20 SUB2008-00064

HOLLEY BRANCH SUBDIVISION RESUBDIVISION OF LOTS 14 AND 15

DETAIL SITE PLAN

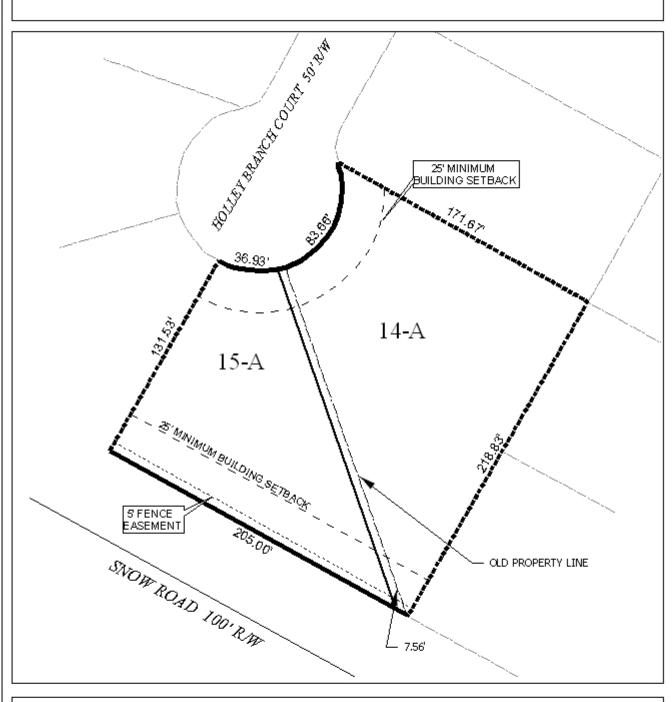
The plat illustrates the proposed $0.8\pm$ acre, 2 lot subdivision, which is located on the East side of Holley Branch Court at its South terminus – within the planning jurisdiction. The applicant states that the site is served by public water and sanitary sewer facilities.

The purpose of this application is to move an interior lot line.

As proposed, Lots 14-A and 15-A have approximately 83' and 36' of frontage respectively along Holley Branch Court. As a means of access management, a note should be placed on the final plat stating that each lot is limited to one curb cut, with the size, location, and design to be approved by County Engineering and conform to AASHTO standards. Furthermore, a note should be placed on the final plat stating that the subdivision is denied direct access to Snow Road.

- 1) placement of a note stating that each lot is limited to one curb cut to Holley Branch Court, with the size, location, and design to be approved by County Engineering and conform to AASHTO standards;

- 2) placement of a note on the final plat stating that the subdivision is denied direct access to Snow Road:
- 3) placement of a note on the plat stating that the site must be developed in compliance with all local, state and Federal regulations regarding endangered, threatened or otherwise protected species;
